SUBJECT: Indian Point 2 and 3 Nuclear Power Plants
Docket Nos. 50-247 and 50-286
License Nos. DPR-26 and DPR-64
"Supplement to 15-Day Response for NRC Bulletin 2002-01"

**SUPPLEMENT TO 15-DAY RESPONSE TO
NRC BULLETIN 2002-01
FOR INDIAN POINT UNIT 2**

FOR INDIAN POINT UNIT 3

SUBJECT: CRDM/RPV VT-2 INSPECTION

FIGURE I
 UNIT 2 REACTOR VESSEL HEAD
 LEAK LOCATIONS AND INSULATION REMOVAL

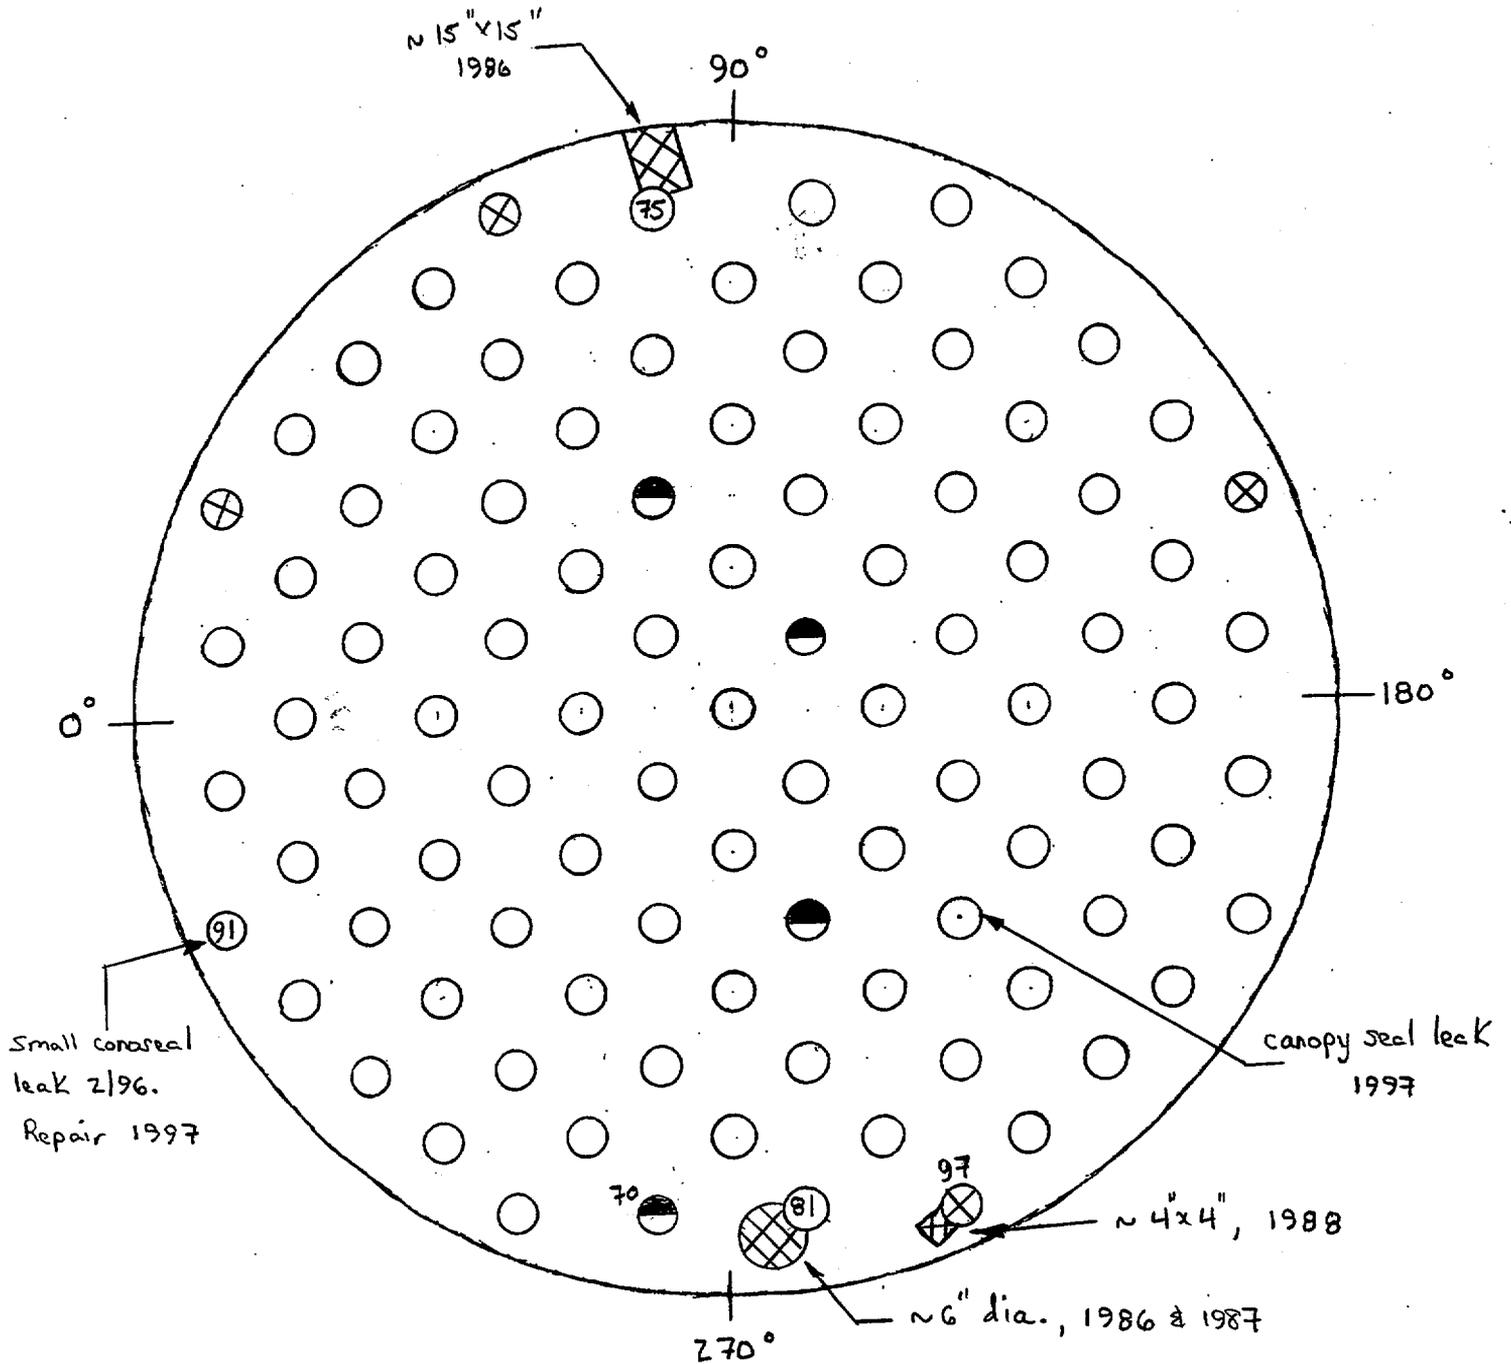
Your 15 day response to Bulletin 2002-01 indicates that sections of insulation adjacent to leaking canopy seal welds were removed in 1986, 1987, and 1988, and a bare-metal inspection of the reactor vessel head was performed. Provide a sketch of the location of the leaks and the locations where the insulation was subsequently removed for each occurrence. Discuss the size (area) of the insulation that was affected by the leaks and the size (area) of the base metal that was exposed. Discuss whether or not any boric acid deposits and/or residue were identified on the bare metal of the head and/or whether any boric acid/water penetrated the insulation.

Removal of insulation and inspection of the bare metal was performed as described below. Locations are shown on Figure I.

- 1986: Approximately 6 inch diameter section removed between nozzles 70 and 81.
Approximately 15 inch x 15 inch section removed adjacent to nozzle 75.
- 1987: Same location as 1986, between nozzles 70 and 81.
- 1988: Approximately 4 inch x 4 inch section removed adjacent to nozzle 97.

In all above cases, no boron accumulation on the vessel head or degradation of base metal was observed, and the head coating (high-temperature aluminum silicate) appeared to be intact. During the 1986 / 1987 inspection and repair efforts, samples of insulation were tested to determine the degree to which the leaking, borated water had penetrated the head insulation. The results of these tests showed that, although the insulation provided some protection against the leaking water contacting the head base metal, some boron was found through the thickness of the insulation, indicating that the insulation is not water tight. However, no visible signs of boron were found on the vessel head.

FIGURE II
 UNIT 3 REACTOR VESSEL HEAD
 PENETRATIONS AND CLOSURE STUD LOCATIONS

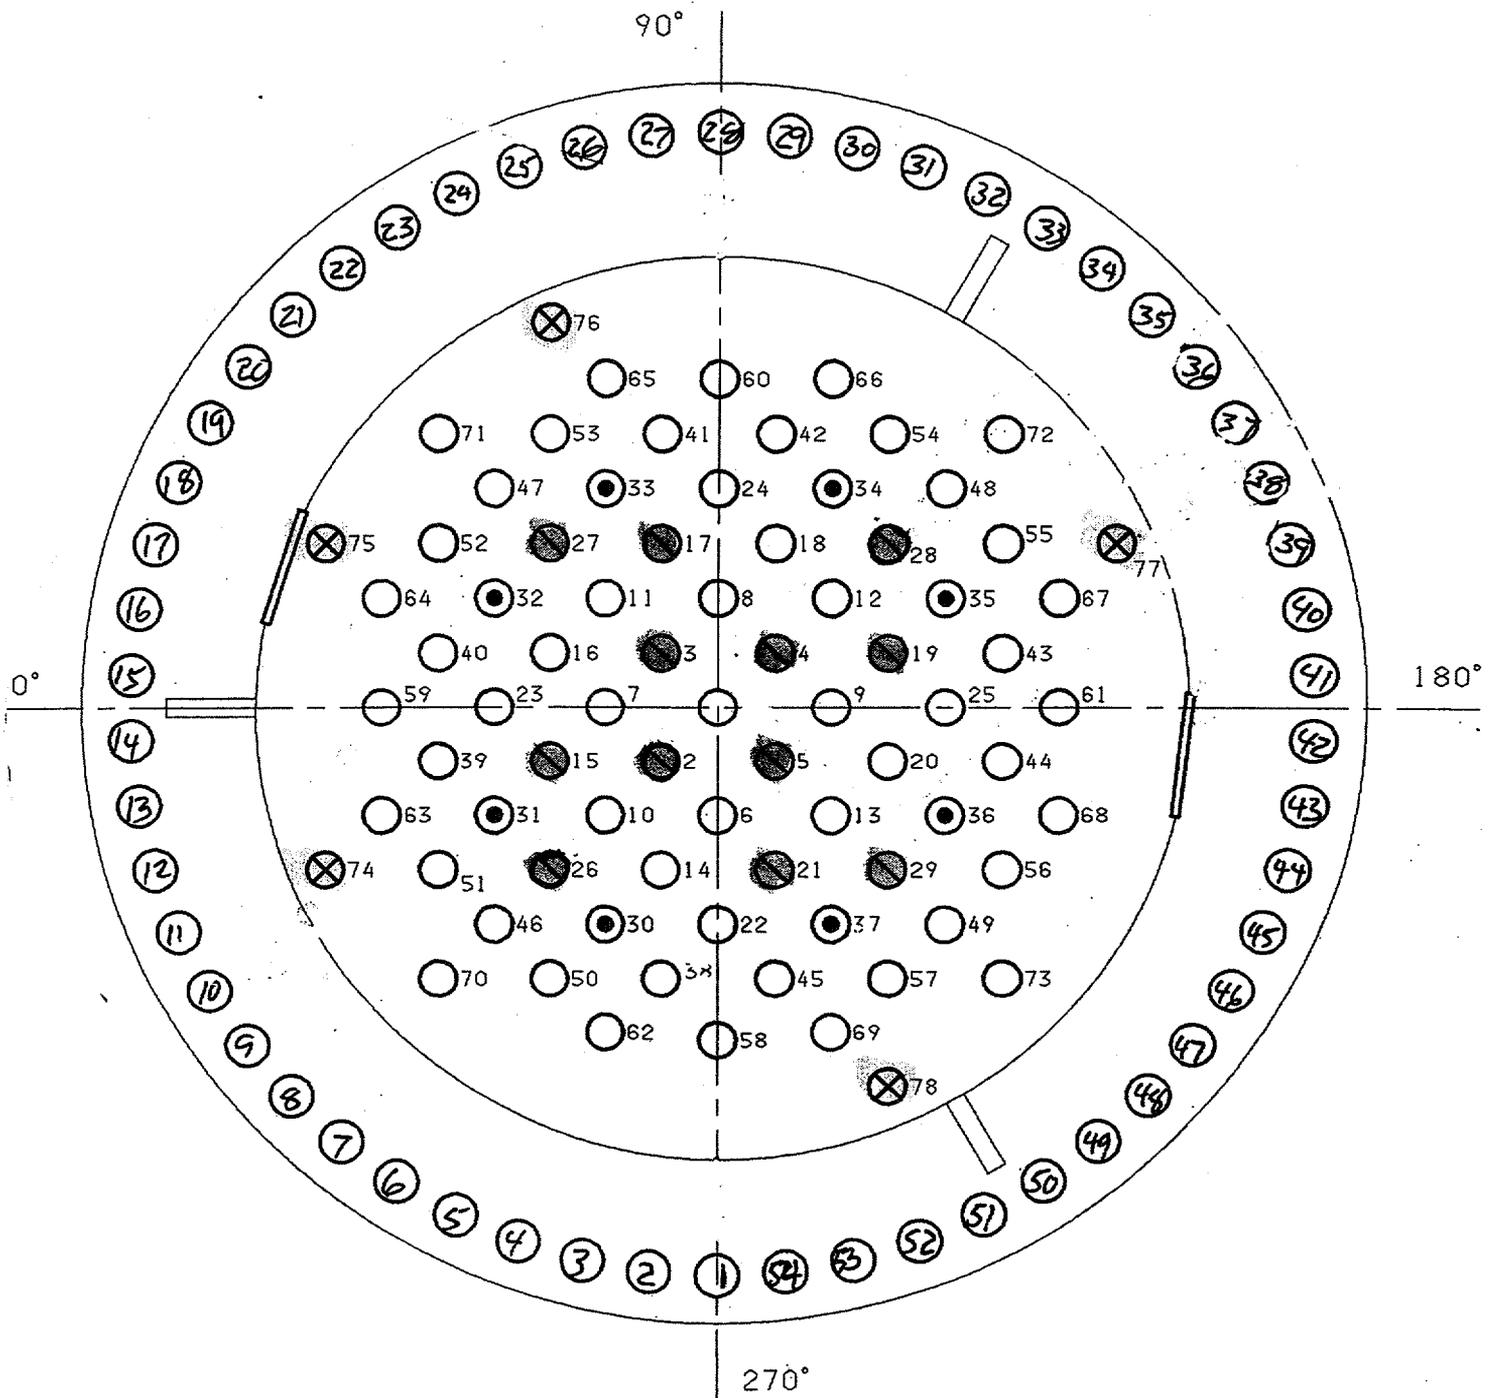
Your 15 day response to Bulletin 2002-01 indicated that insulation around 14 CRDMs was removed, and inspections were performed due to a canopy seal leak that was identified in 1990. Discuss whether or not any boric acid deposits and/or residue were identified on the bare metal of the head and/or whether any boric acid/water penetrated the insulation. Clarify whether or not this area is still accessible, and if accessible, discuss the inspections that have been performed.

A plan view of the Unit 3 reactor vessel head is provided in Figure II to show the relative locations of areas described in answers to several of the NRC questions.

Leakage from the canopy seal on CRDM 28 was detected during startup from a scheduled outage in March 1990. A clamp assembly was installed (Work Request 21446) to repair the leak and the wetted insulation over an area approximately 3 feet by 5 feet was removed (Work Request 21284). In addition, a clamp assembly was installed on CRDM 26 (Work Request 21447) because boric acid residue was found on the canopy seal area, although no active leakage was detected. Prior to installing new insulation, the reactor vessel head was cleaned and inspected in the area of removed insulation. No corrosion was noted in the work package documentation.
